## ADDENDUM

**ADDENDUM NO.:** 01  
**PROJECT NAME:** CIP Central Hearing Facility Roof and MEP Upgrades  
**PROJECT NO.:** 04044  
**CONTRACT NO.:** C1606  
**DATE OF ISSUE:** December 21, 2023

### NOTICE OF CHANGES, MODIFICATIONS, OR CLARIFICATIONS TO CONTRACT DOCUMENTS

Sheet  
**E-102E**

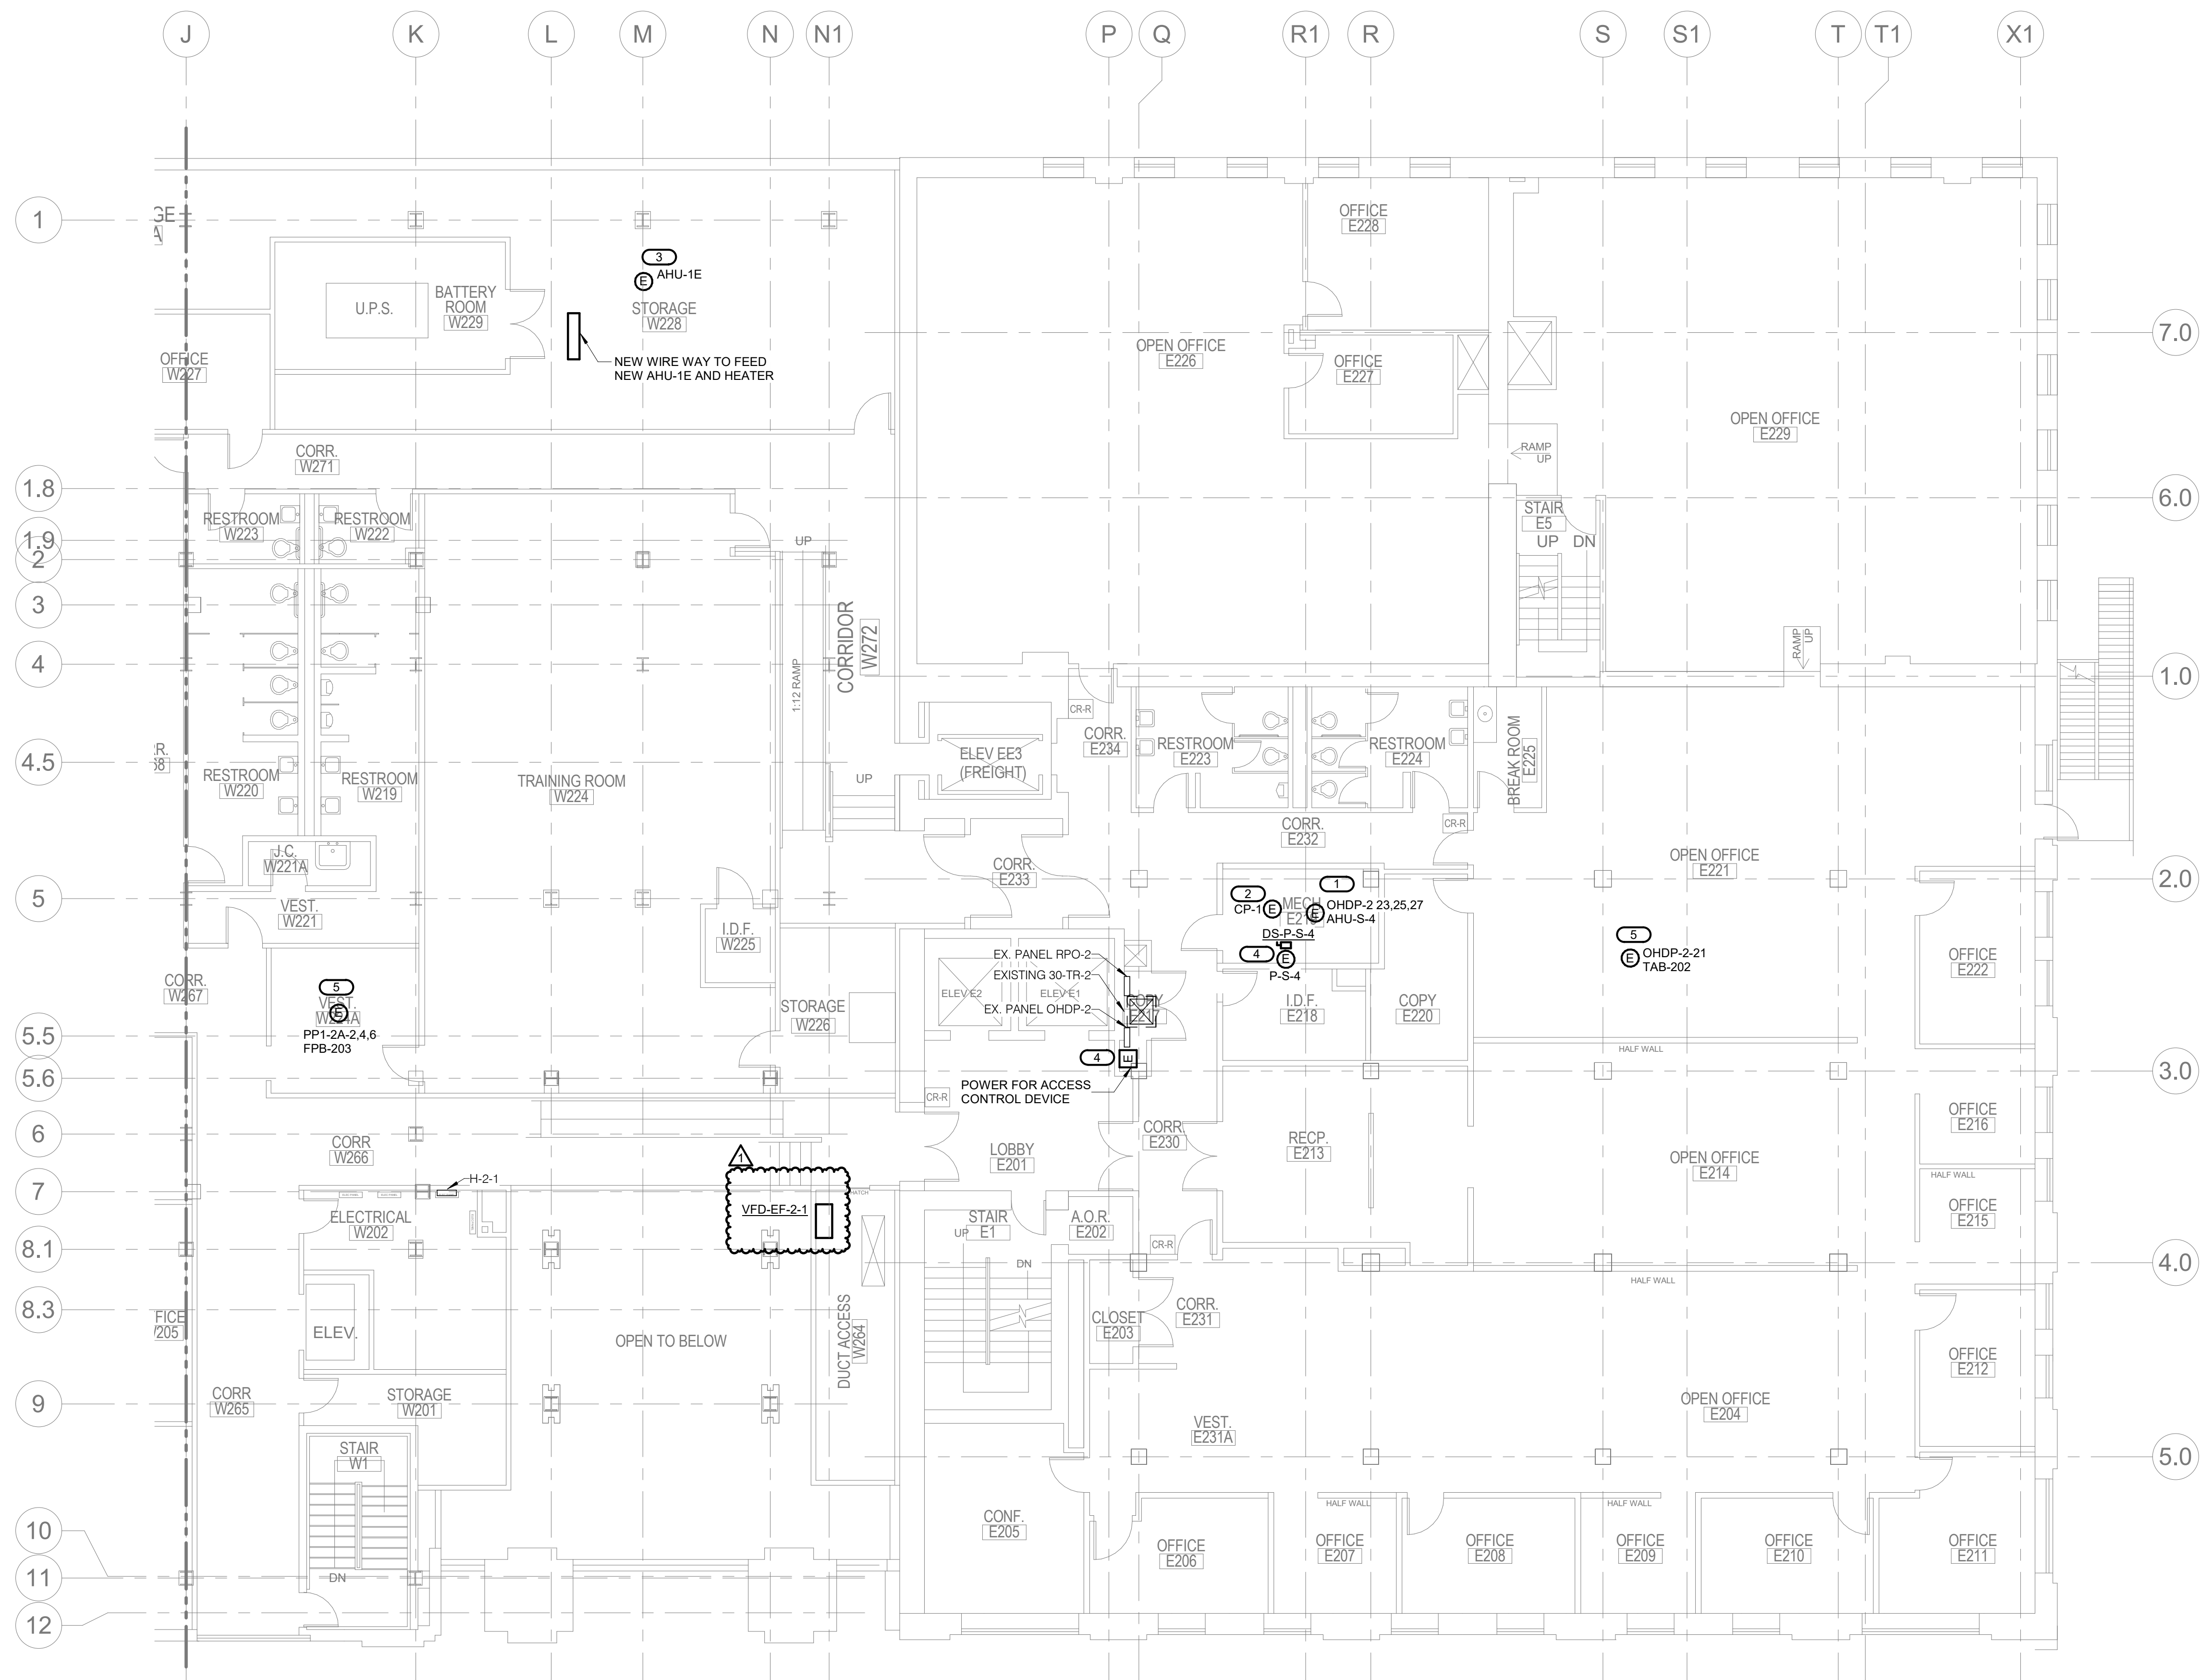
**Change 15** Drawing No. MD-104 – **REVISED** sheet to reflect updates above Room E449, dated 12.21.23  
**Change 16** Drawings No. E-102E-**REVISED** sheet to add VFD, Dated 12.21.23

**Question:** Are new VFDs being installed for each AHU? What type of BAS will be installed?

**Response:** Yes, new VFD's are called out to be installed for all AHUs. AHUs are shown for replacement on electrical drawings. AHUs being replaced are scheduled on the mechanical drawings to be provided with factory mounted VFD's.

PBC Project Name: CIP - Central Hearing Facility Roof and MEP Upgrades  
PBC Contract No: C1606  
Project No.: 04044  
Title  
SIXTH FLOOR EAST PLAN - POWER

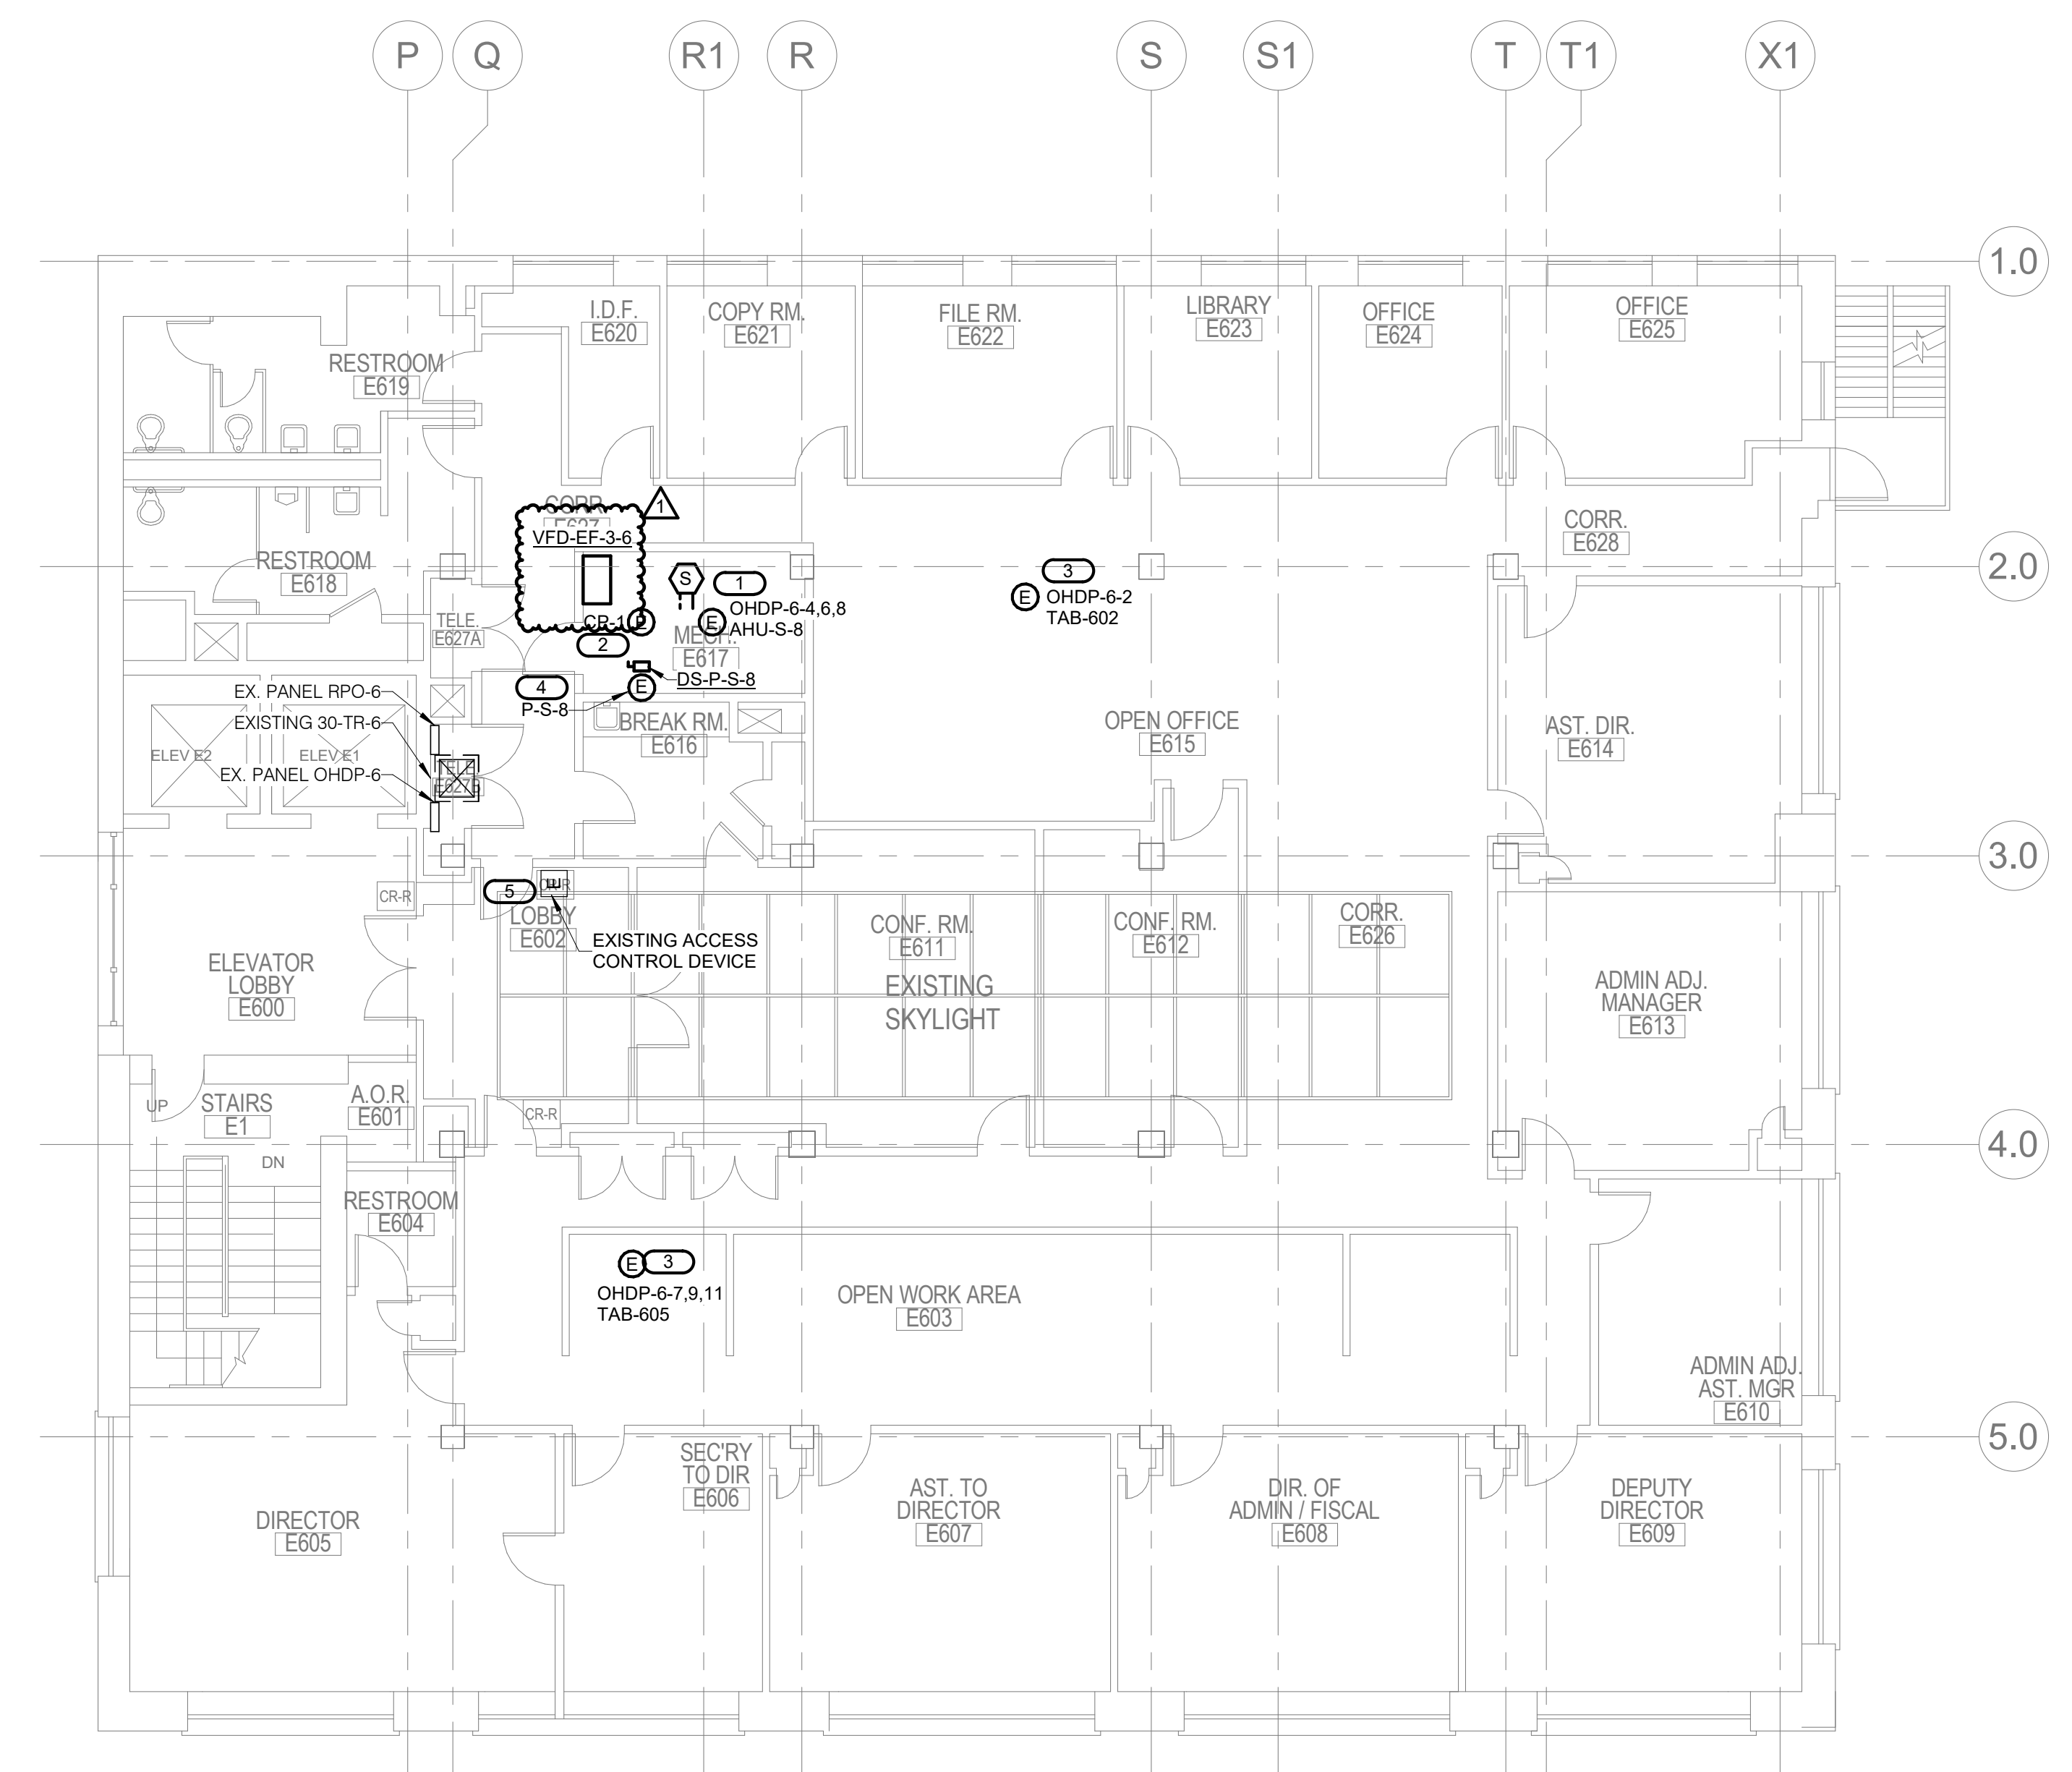
**Change 17** Drawing No. E-106 – **REVISED** sheet to update VFD in Room E617, dated 12.21.23  
**Change 18** Drawing E-500 – **REVISED** Variable Frequency Drive Schedule, dated 12.21.23
